**FINAL**  
**ENVIRONMENTAL IMPACT STATEMENT**  
**OF THE PROPOSED**  
**GROUND BASED FREE ELECTRON LASER**  
**TECHNOLOGY INTEGRATION EXPERIMENT**  
**WHITE SANDS MISSILE RANGE**  
**NEW MEXICO**

Document Designation: Final EIS

### C. Public Review and Comment

Figure I-2. WSMR and Associated Co-Use Areas.

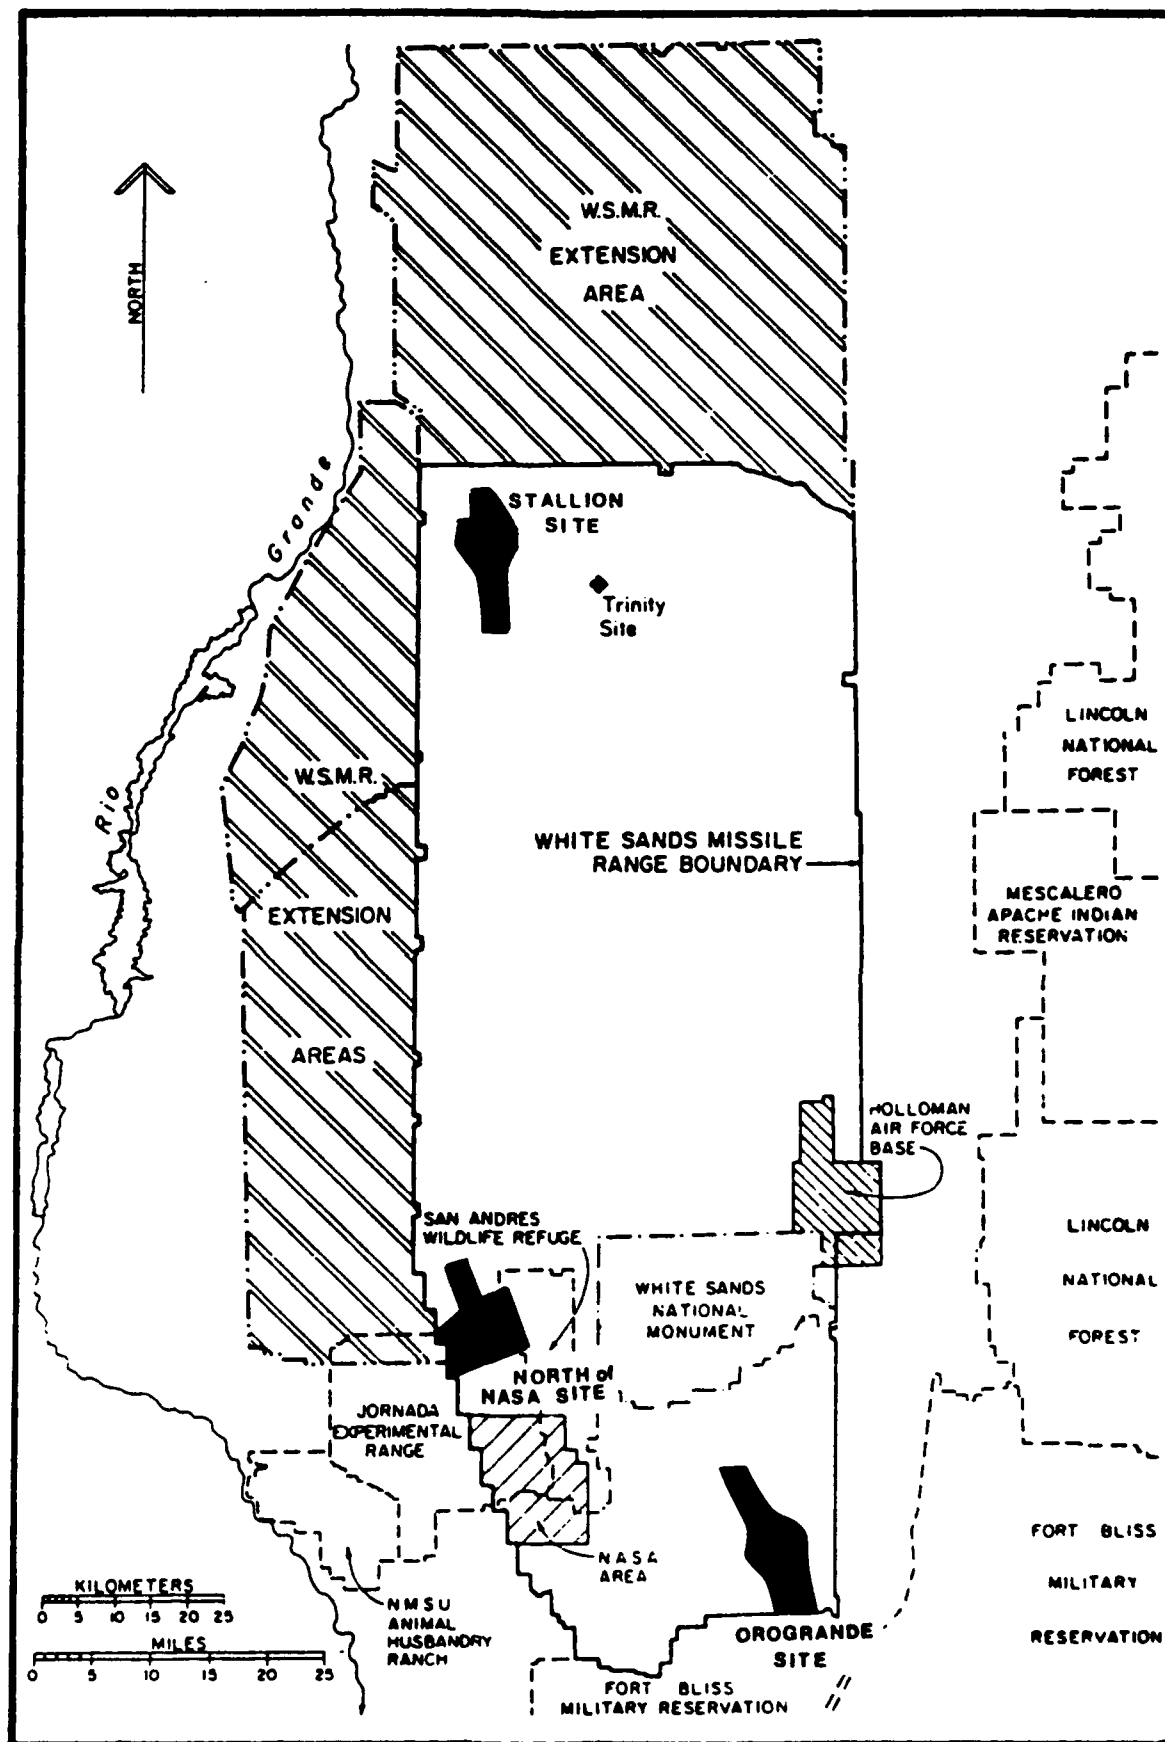
3. The title for Figure 1-2 on page I-3 should be "USNR and associated U.S. Department of the Interior co-use areas." The USNR extension areas are covered by a memorandum of understanding (MOU) dated February 16, 1973, between the Department of the Army and the U.S. Department of the Interior (BLM and USNR).

M-1.3 This correction has been made to the indicated figure (Figure 1-2).

Figure I-4. GBFEL-TIE Facility Orientation at Stallion Candidate Site.

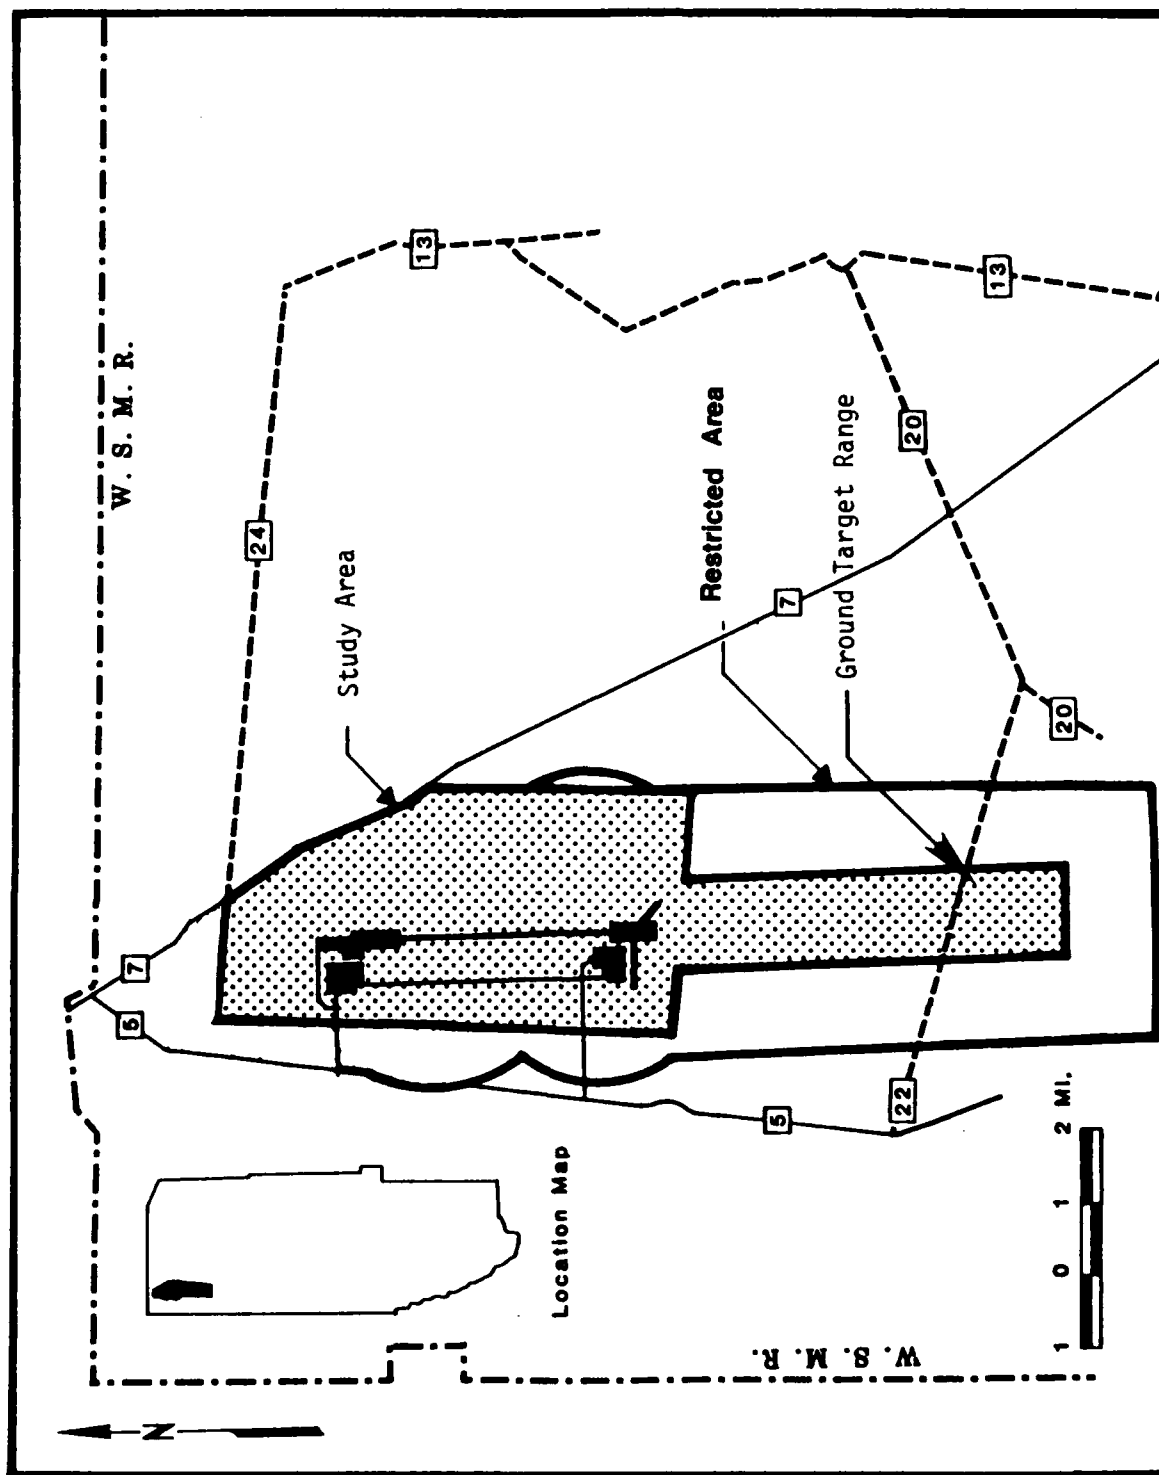
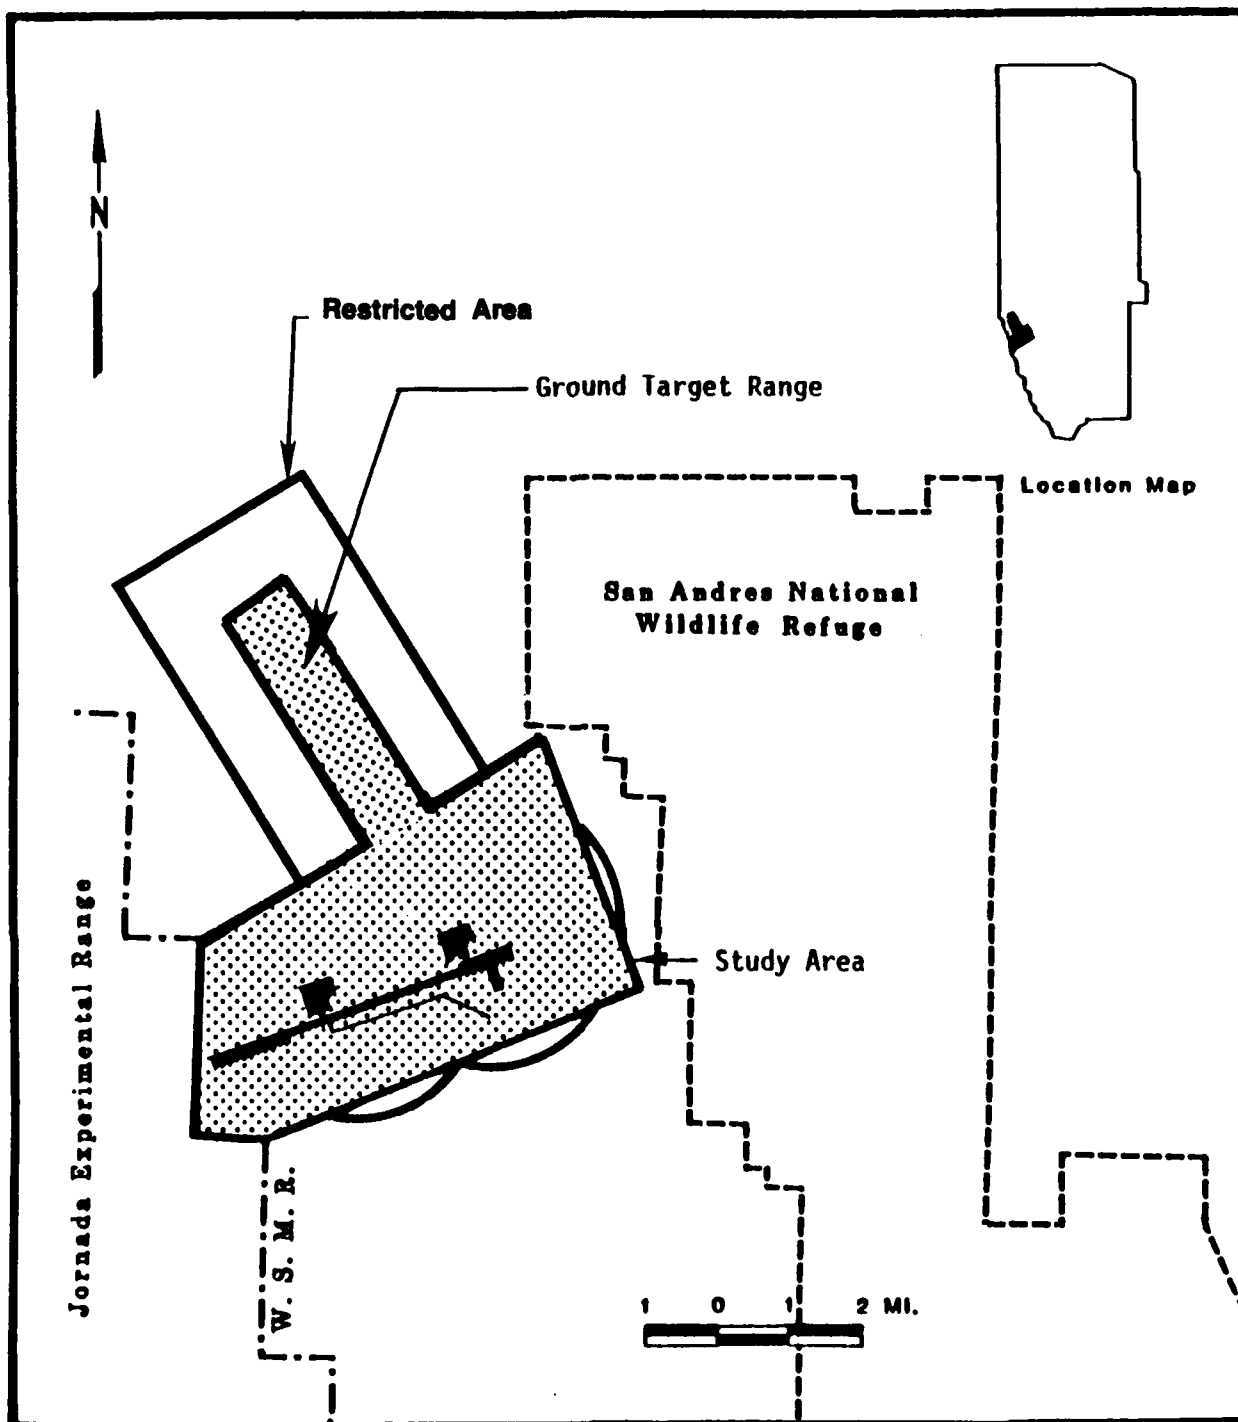
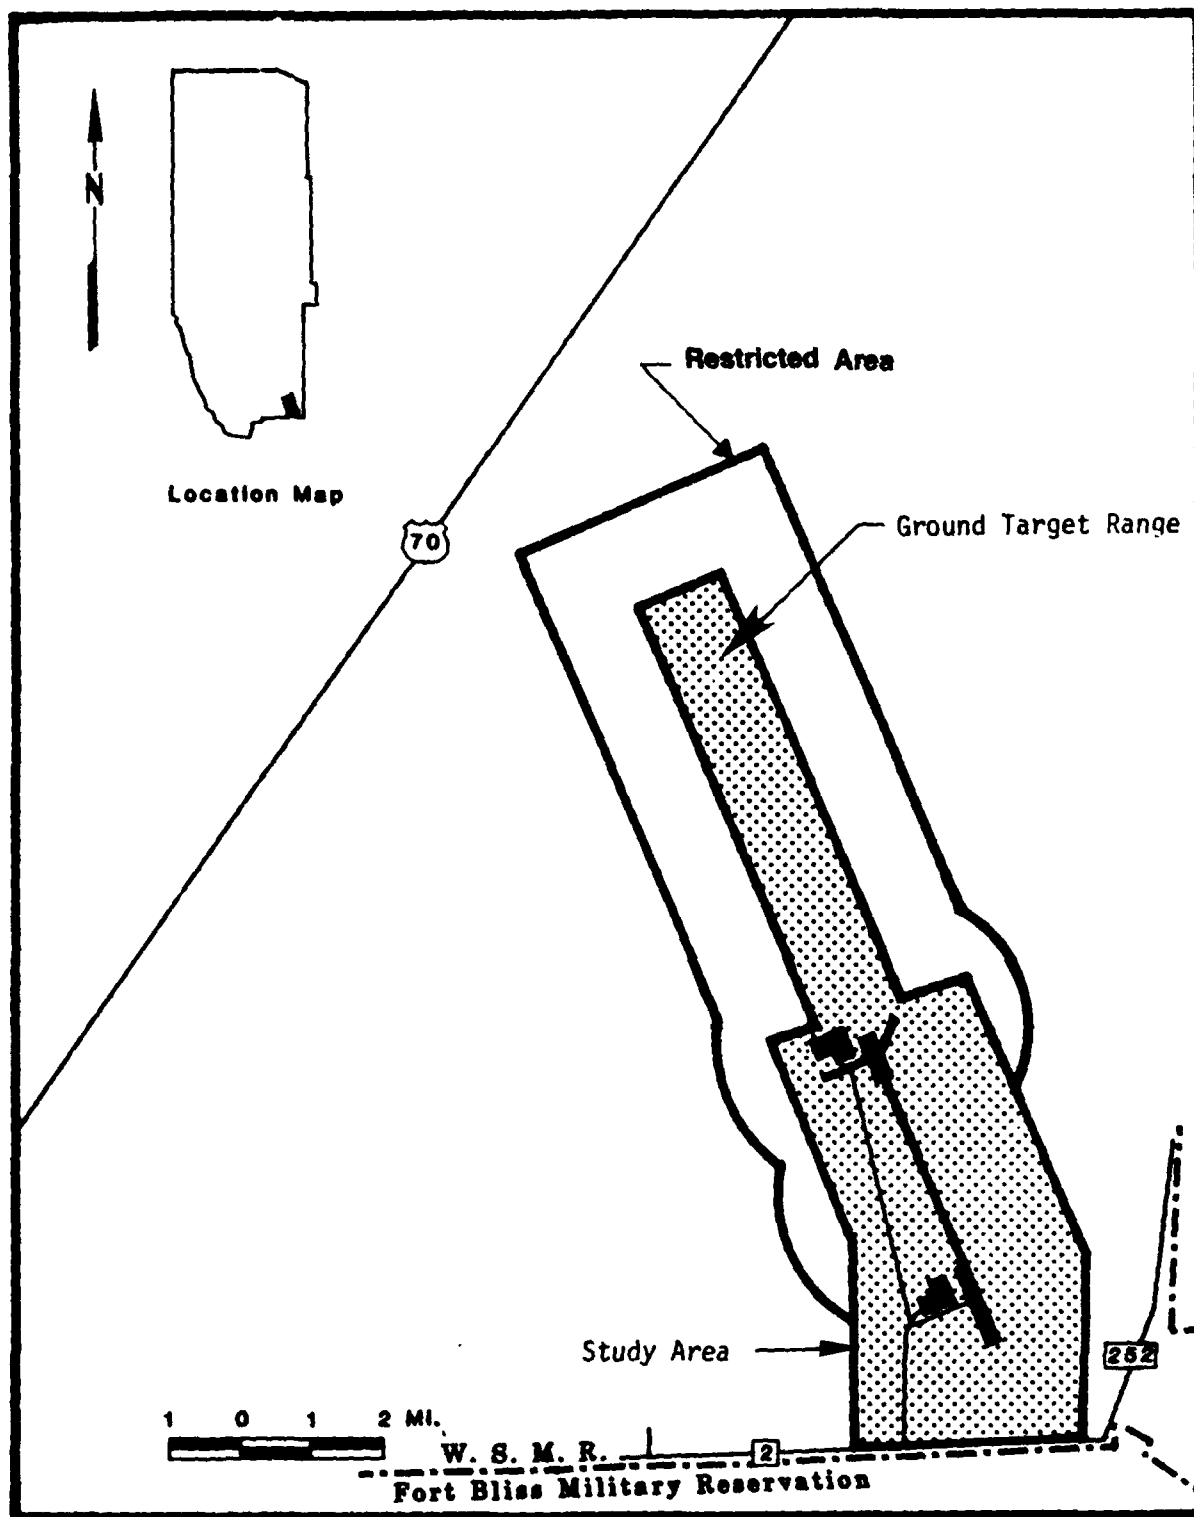
- a. Page 1-3 through 1-9: The land area descriptions given in paragraph B.1. on page 1-3 are different than those shown in Figure 1-4, 1-5 and 1-6. This must be corrected.
